DESIGN ADVISORY BOARD Tuesday, March 24, 2015 at 3:00 PM Conference Room 12, City Hall, Burlington, VT

TO: Design Advisory Board
FROM: Scott Gustin
DATE: March 24, 2015
RE: 15-0809CA/MA, 316-322 Flynn Avenue

Request: Remove existing deli building and replace with new mixed use (deli, office, 9 residential units) building and associated site improvements.

Project **PINE & FLYNN**
TRASH ENCLOSURE DETAILS
Drawing Title
Project No. 2011-03 Drawn By **MFA**
Floor(s) - N.A.
Drawing No. **L-4**

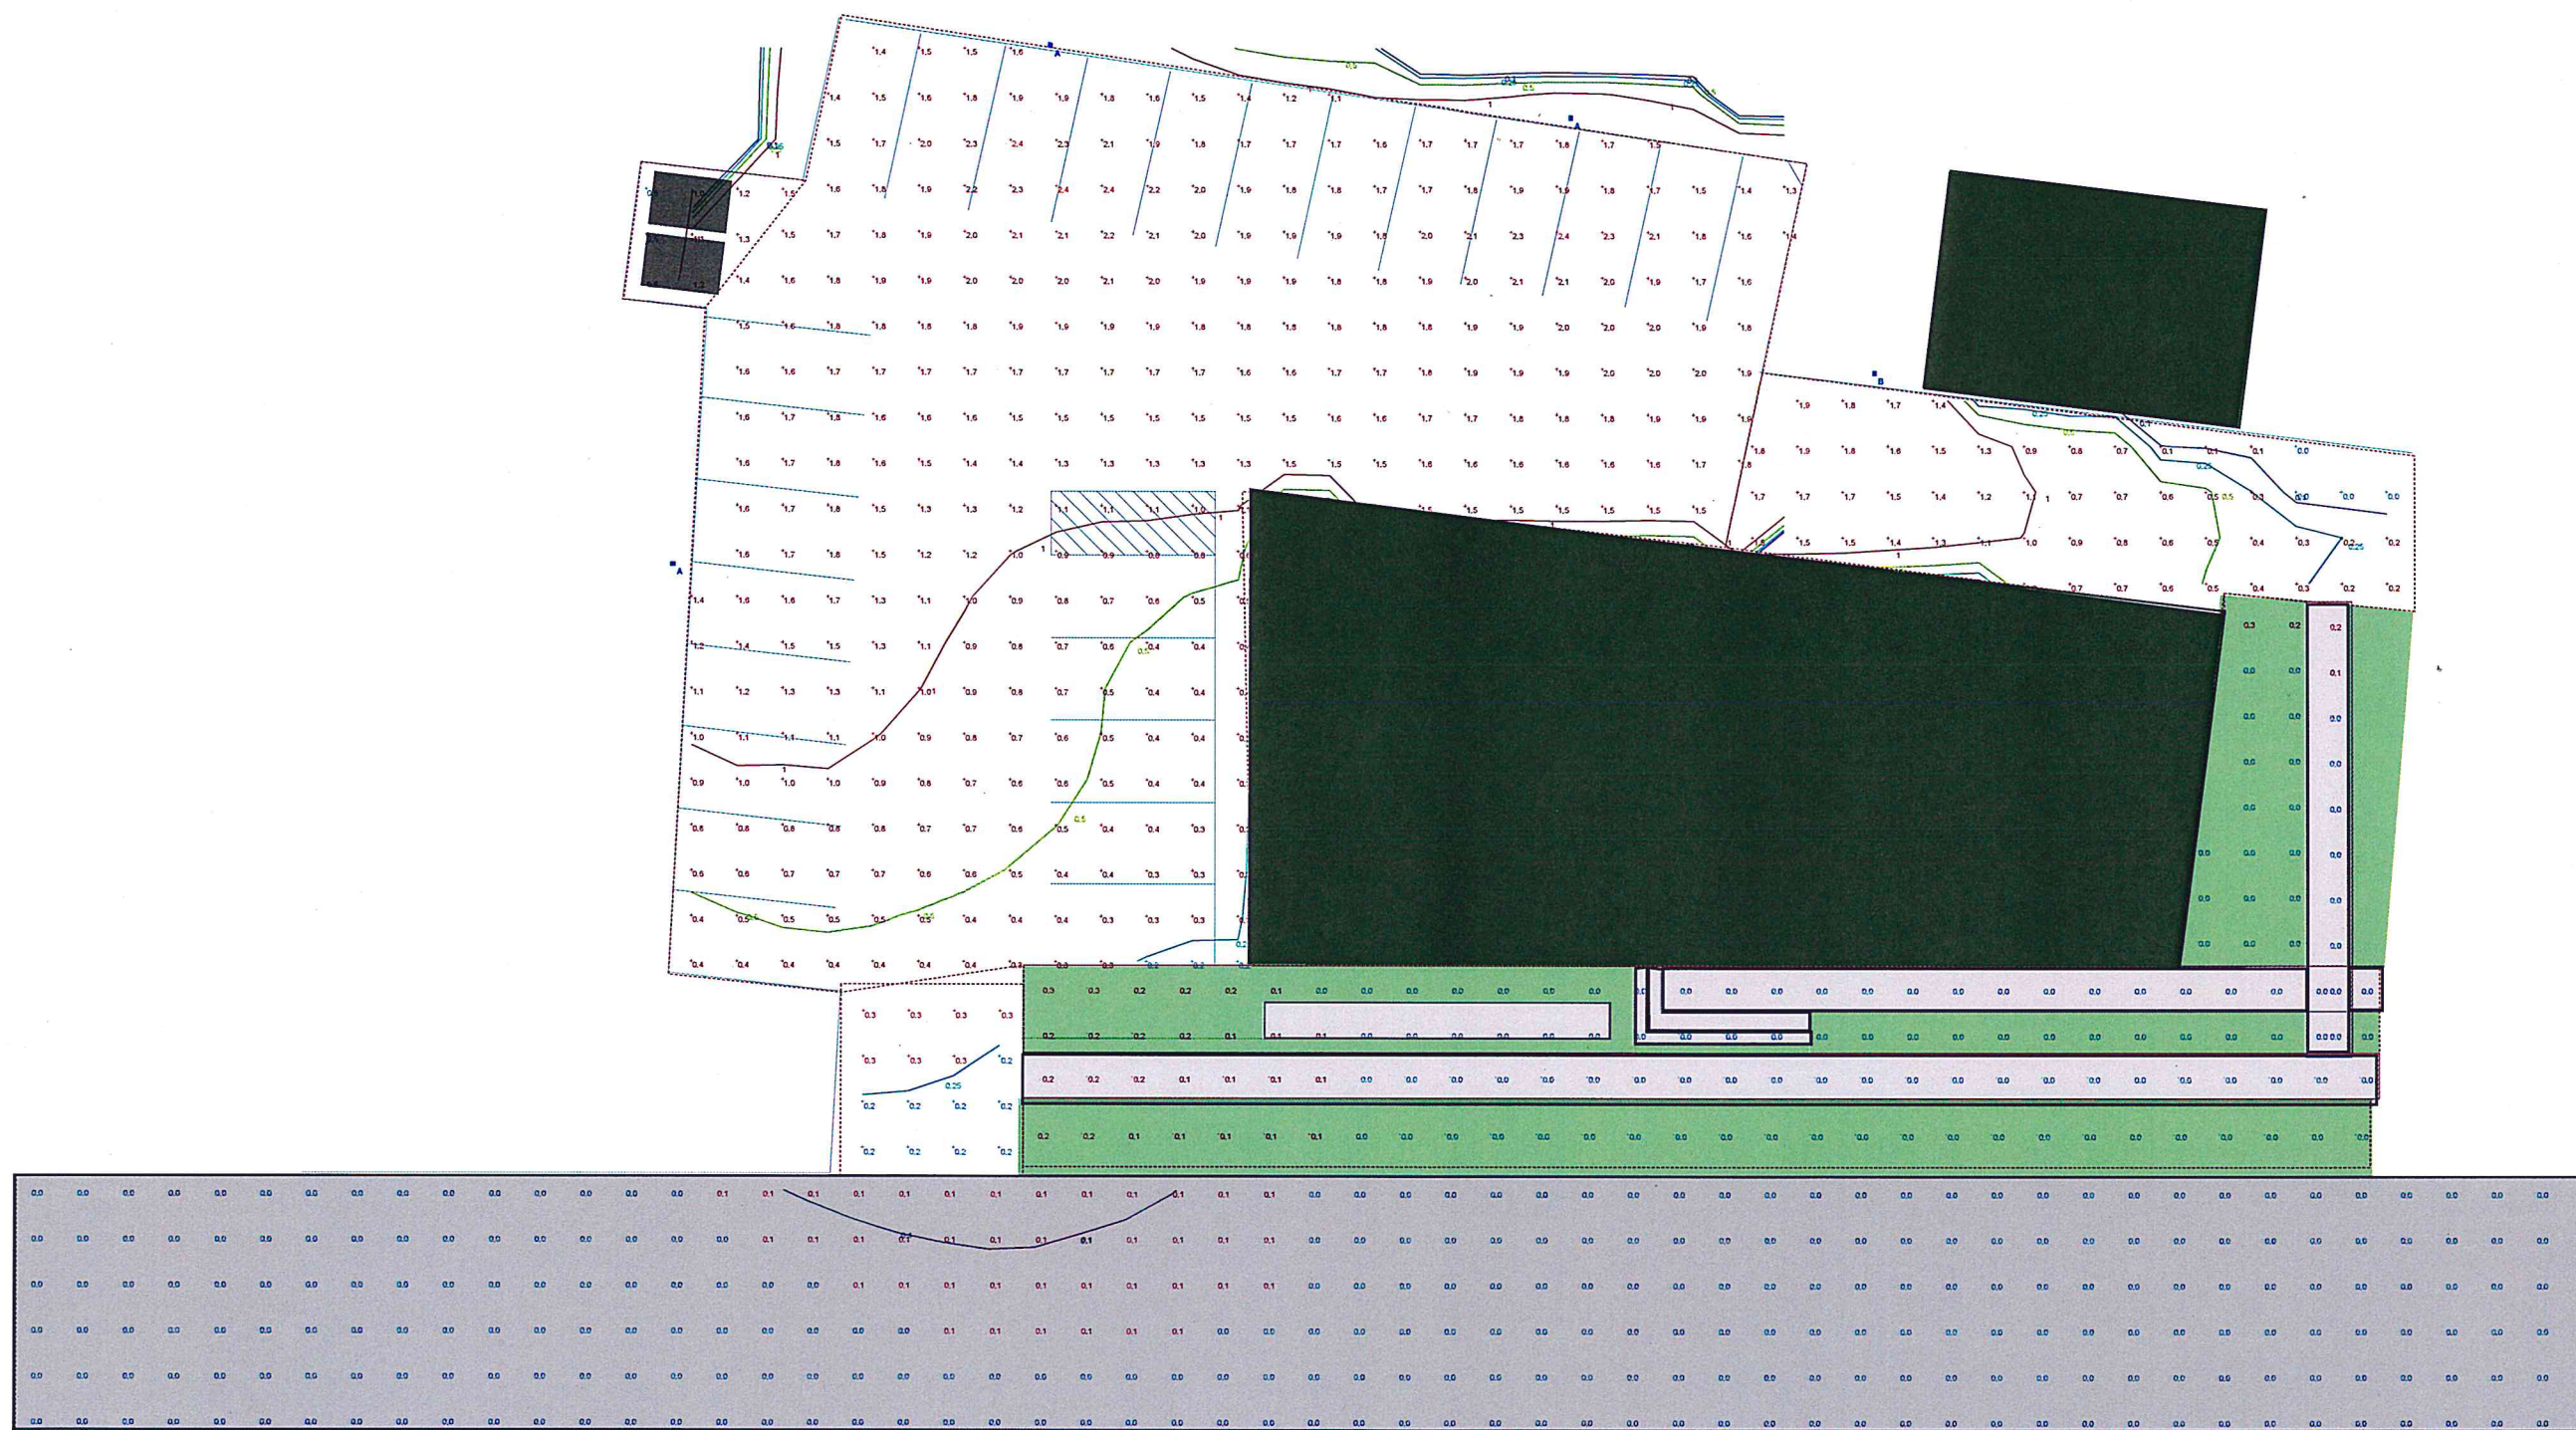
All utility lines must be buried. No ground-mounted mechanical equipment is included in the proposal. A trash and recycling enclosure will be provided at the northeast corner of the parking

area. The enclosure will be 8' tall with cedar siding and front gates. It will be set on a concrete pad.

Isofootcandle plots for the DSX0 LED 40C 1000 40K. Distances are in units of mounting height (20').

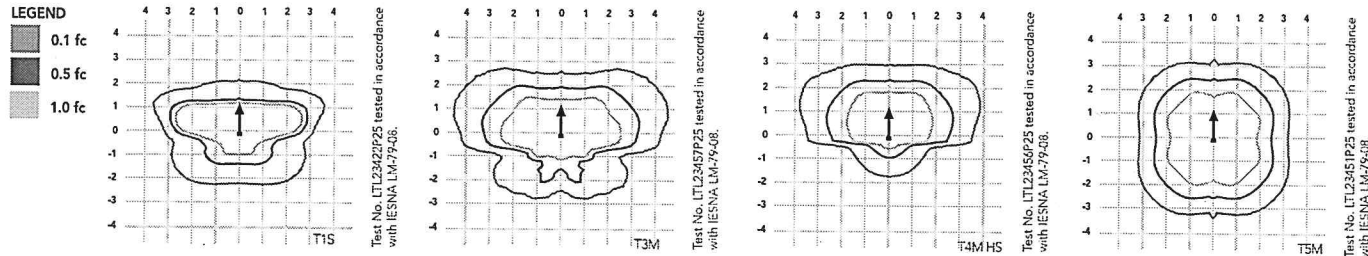
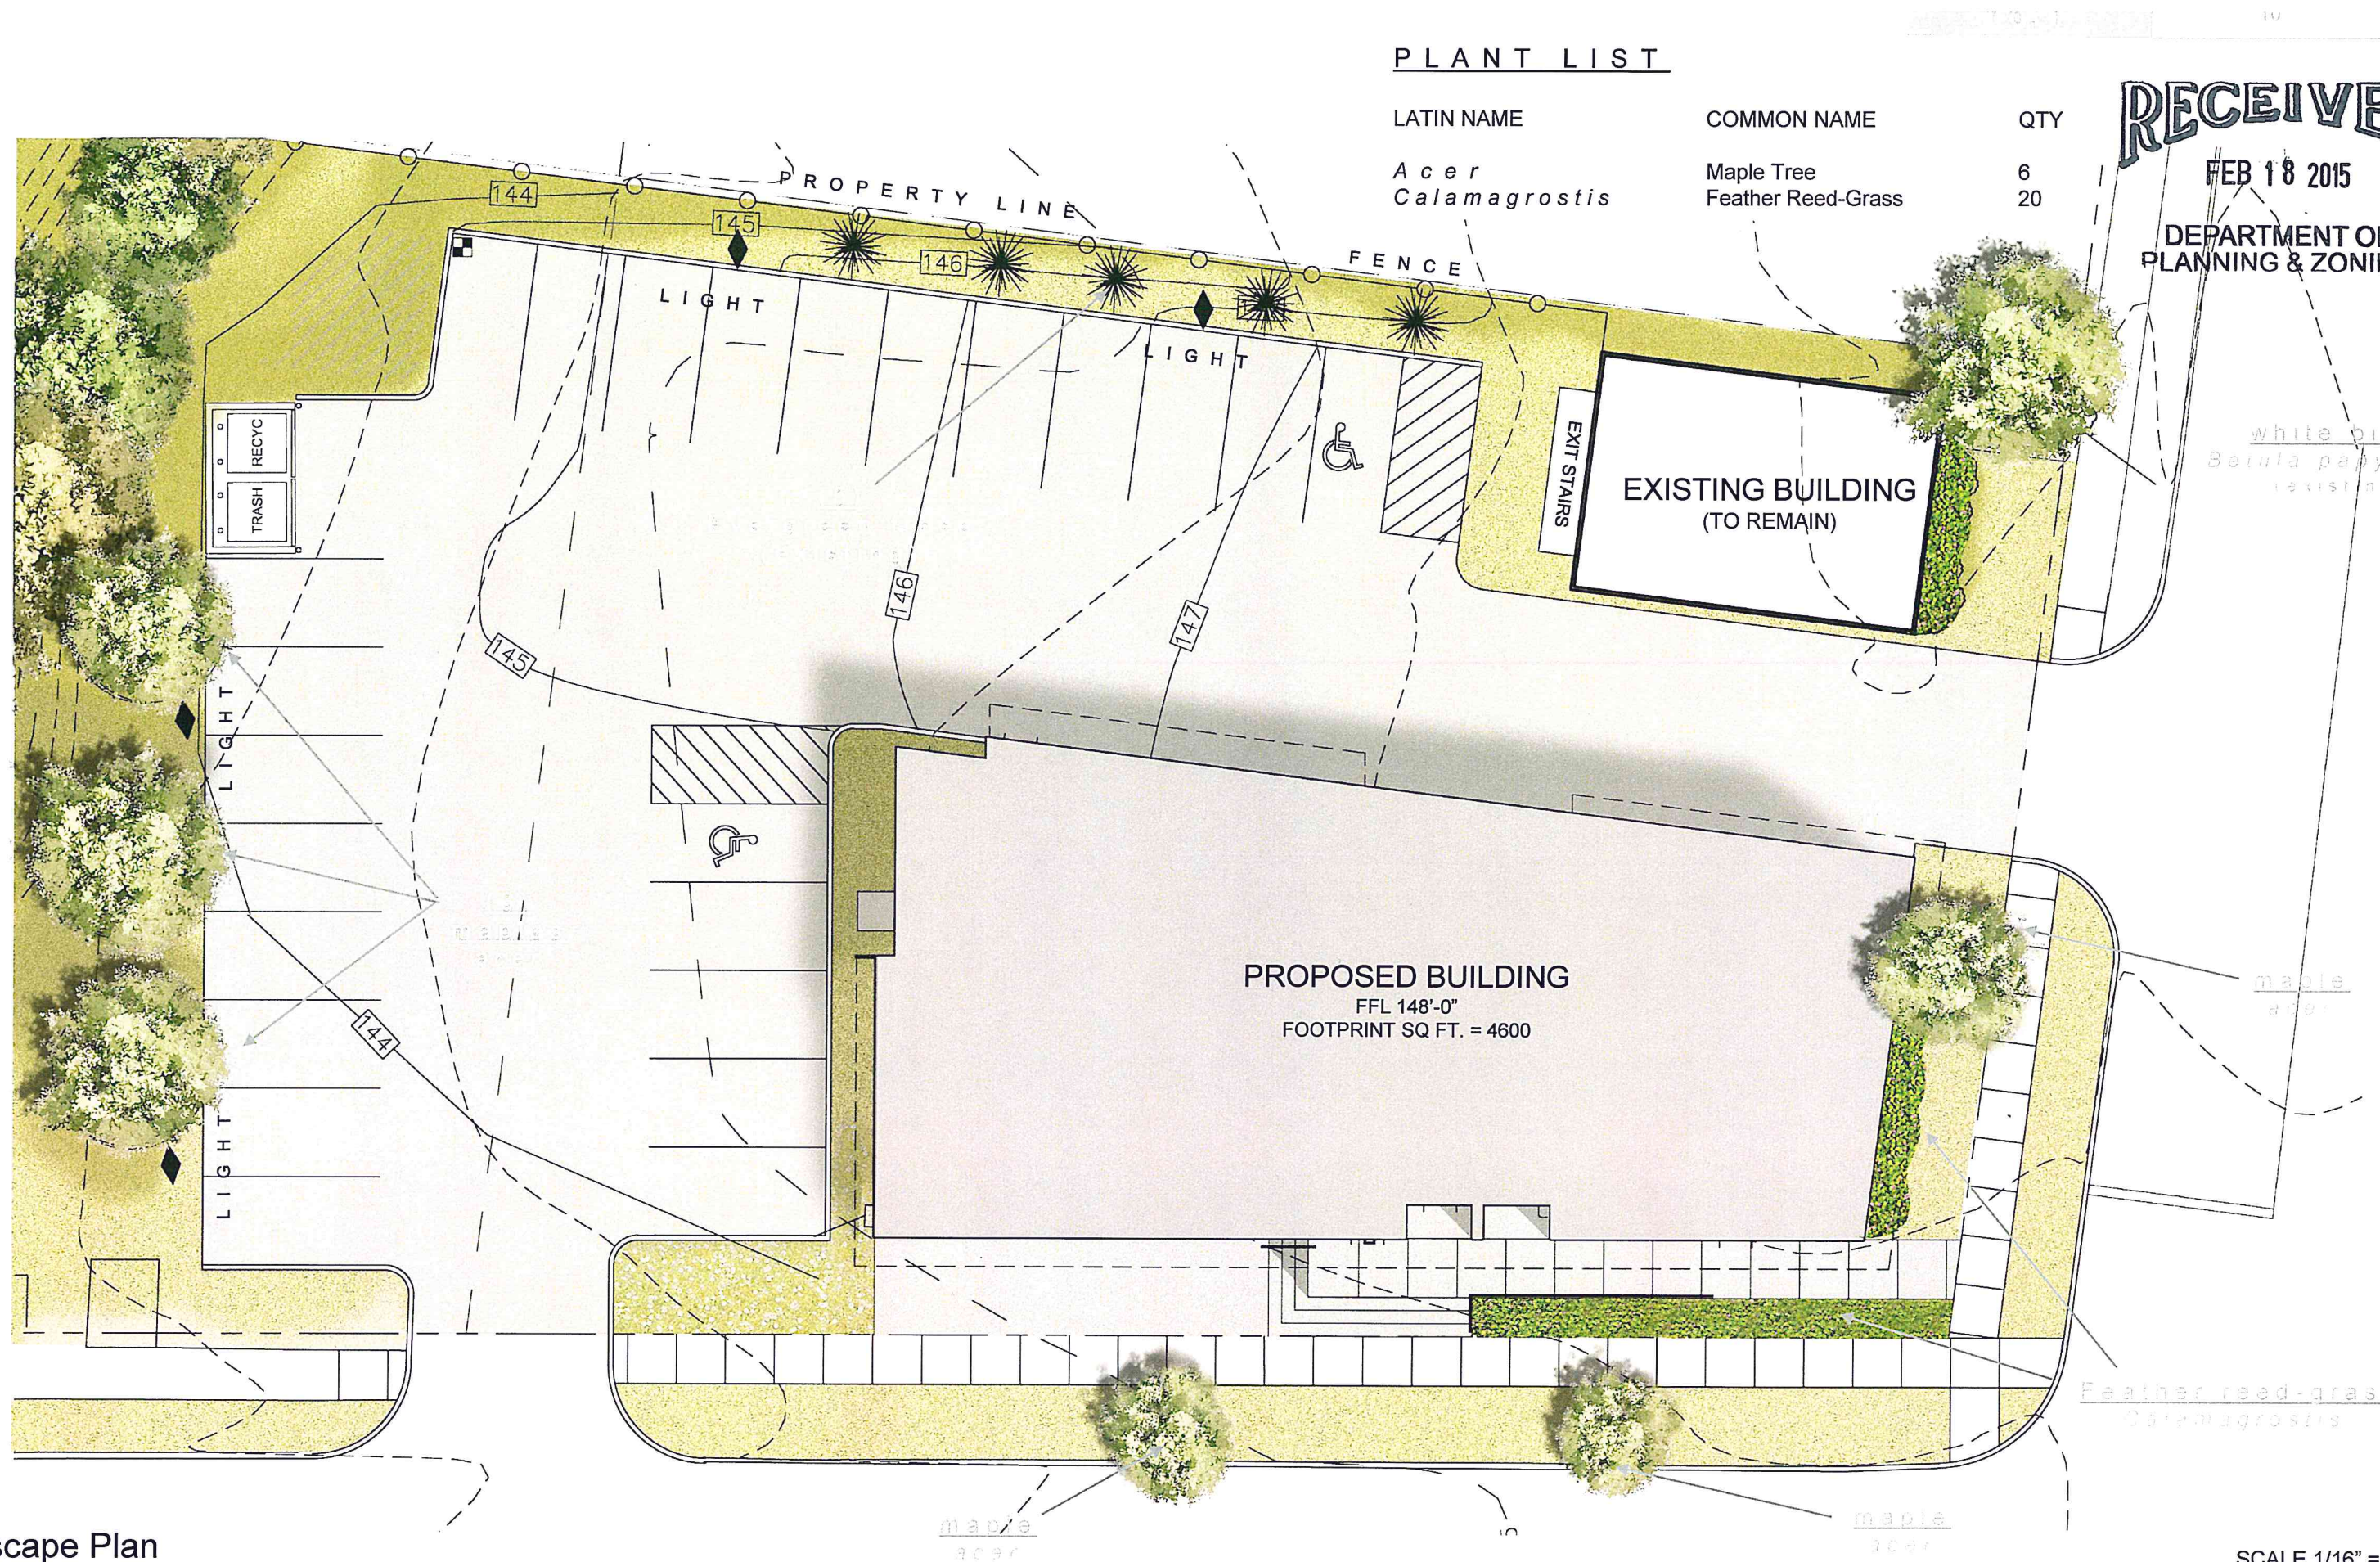
A photometric plan and fixture cutsheet have been provided for outdoor lighting; however, the information is limited only to parking and circulation. The parking and circulation illumination levels are acceptable. A satisfactory cutoff LED luminaire will be used to provide the illumination. The mounting height of the pole-mounted luminaire is not noted and must be.

5. Lighting fixture cutsheets and illumination levels (footcandles or lumens) are needed to all proposed outdoor lighting. Mounting heights of the parking/circulation lighting fixtures needs to be indicated.
